# Lower Thames Crossing

## 7.5 Design Principles (Tracked changes version)

Planning Inspectorate Scheme Ref: TR010032  
Application Document Ref: TR010032/APP/7.5

<b>Version</b>	<b>Date</b>	<b>Submitted at</b>
1.0	31 October 2022	DCO Application
2.0	24 August 2023	Deadline 3
<u>3.0</u>	<u>19 September 2023</u>	<u>Deadline 4</u>

Plate 5.3 Section 1 – Blue Bell Hill Nitrogen Deposition Compensation site (south-east of A2/M2 Corridor)

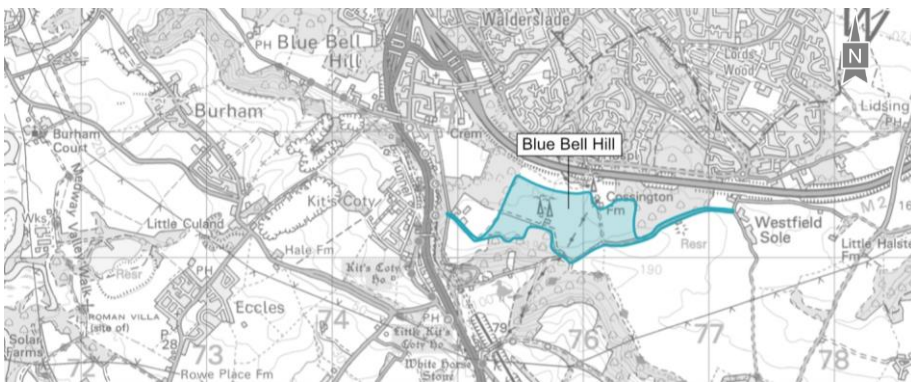
Deleted: sites
